Work Order ID 102424

Item Name: Crosstube Aft

DART AEROSPACE LTD		Work Order:	102424
Description: Crosstube High Aft (412)		Part Number:	D412-664-203
Inspection Dwg: D412-664-243 Rev: E		Page 1 of 1

DRAWING NO. D412-664-243	TITLE CROSSTUBE ASSEMBLY (412 HI AFT)	REV. E	DART AEROSPACE LTD ENGINEERING ORDER		D.E.O. NO. D412-664-243-E-4	SHEET NO. SHEET 1 OF 3	SCALE NTS
DRAWN 9	CHECKED A	MFG. APPR. A	APPROVED MP		DE APPR. MP		
DATE 12.08.21	DATE 12.08.30	DATE 12.08.30	DATE 12/8/30		DATE 12.08-30

D412-664-603
BENT TUBE

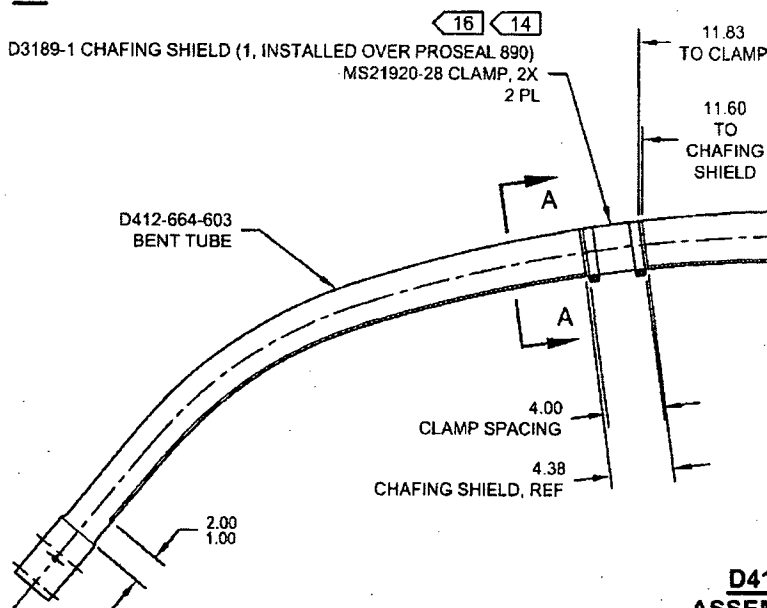
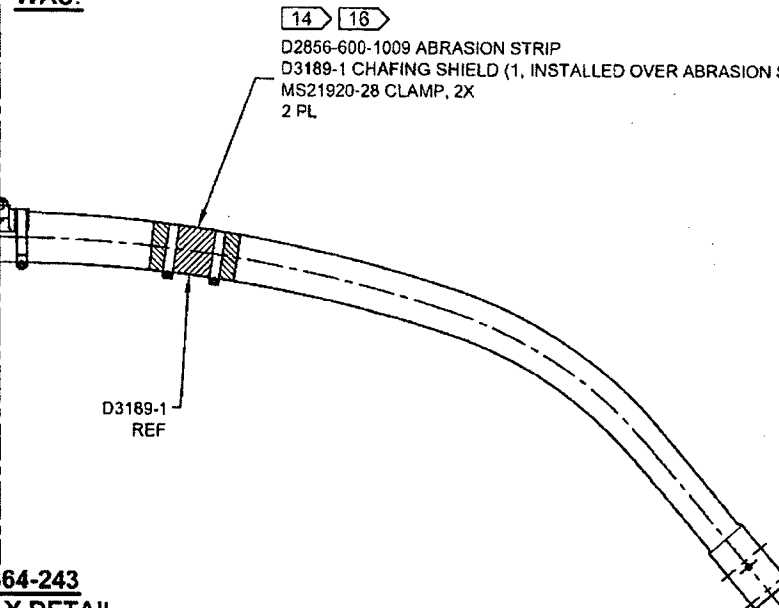
REMOVED ABRASION STRIP IN FAVOR OF A THIN LAYER OF PROSEAL 890. UPDATE INSTALLATION OF CHAFING SHIELDS AND REDUCE TORQUE TO 40-50 IN-LBS. THIS ENGINEERING ORDER SUPERCEDES DEO D412-664-243-E-1.

D3189-1 CHAFING SHIELD (1, INSTALLED OVER PROSEAL 890)
MS21920-28 CLAMP, 2X
2 PL

D2856-600-1009 ABRASION STRIP
D3189-1 CHAFING SHIELD (1, INSTALLED OVER ABRASION STRIP)
MS21920-28 CLAMP, 2X
2 PL

**D412-664-243
ASSEMBLY DETAIL**

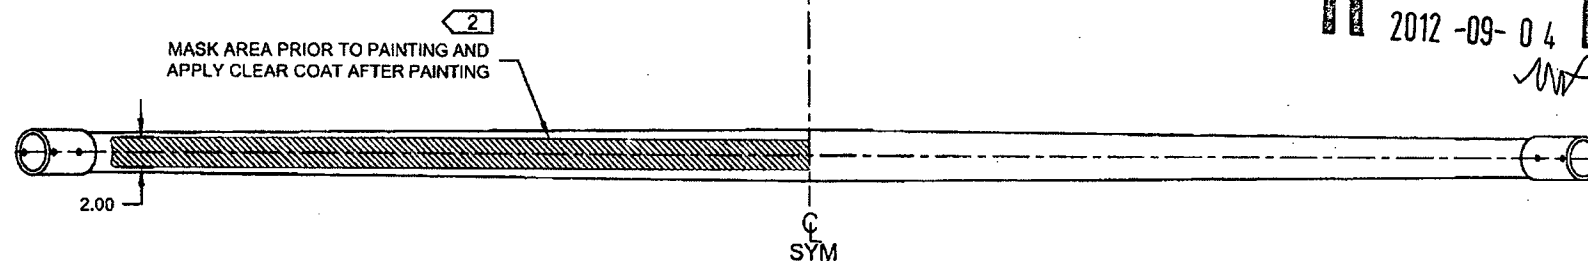
MASK AREA PRIOR TO PAINTING AND
APPLY CLEAR COAT AFTER PAINTING
